SS: 1033464 - WST 5700XE Sun Visor - LED Skirt Marker Valance Lights water ingress.

WST 5700XE

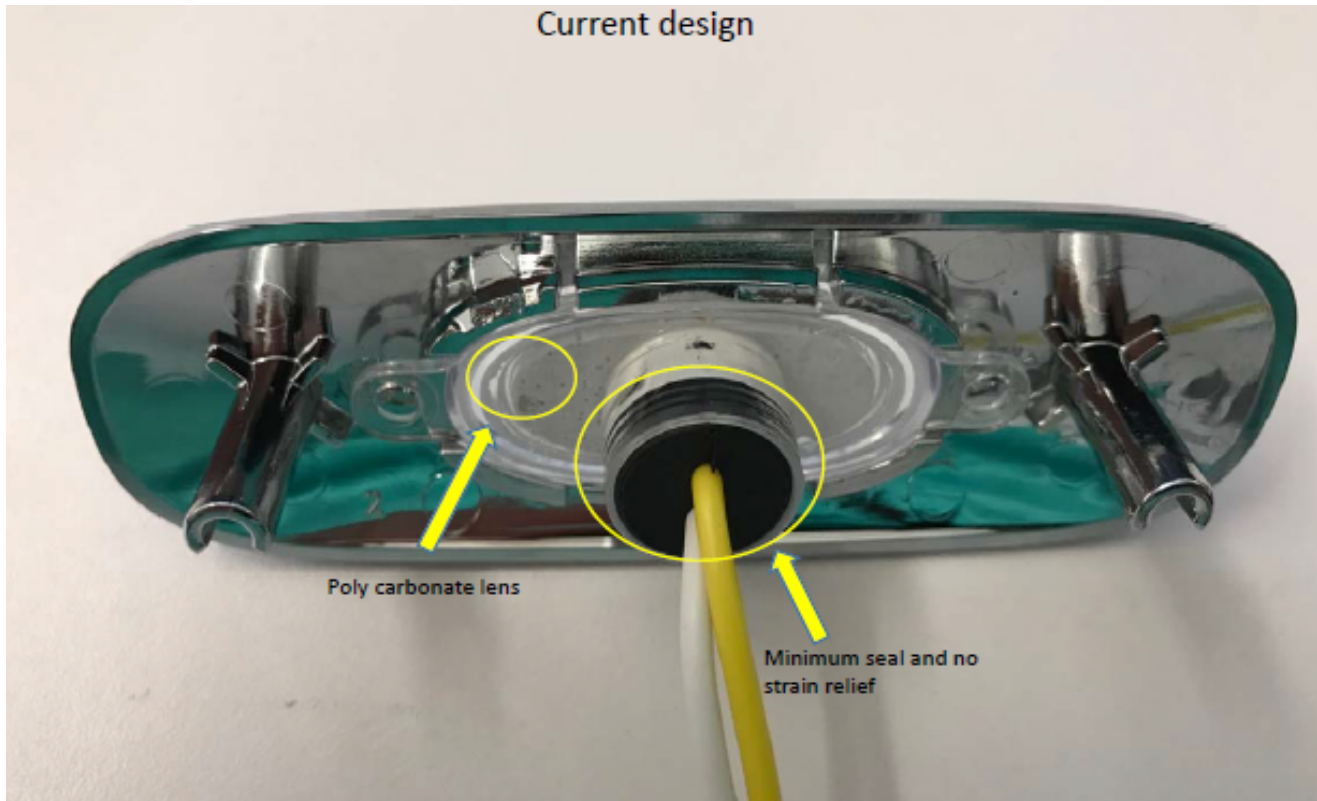
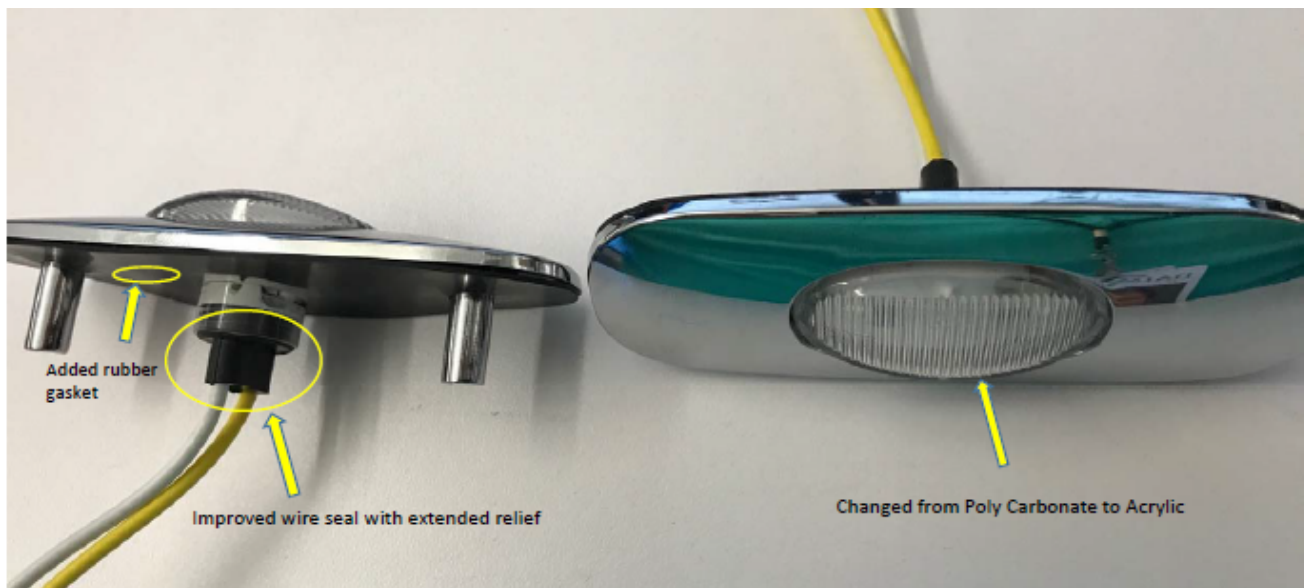
Current LED Marker Valance Lights installation exposes Lights to water splash and chemical contamination that causes plastic material cracks and water/moisture intrusion resulting in Lights early failures.

Supplier developed new Marker Valance Light Assemblies with new plastic material more resistant to corrosion and added a seal gasket to provide also a better connector water/moisture sealing.

New parts went into production on March 28, 2018. New parts are available at the PDCs under same part number.
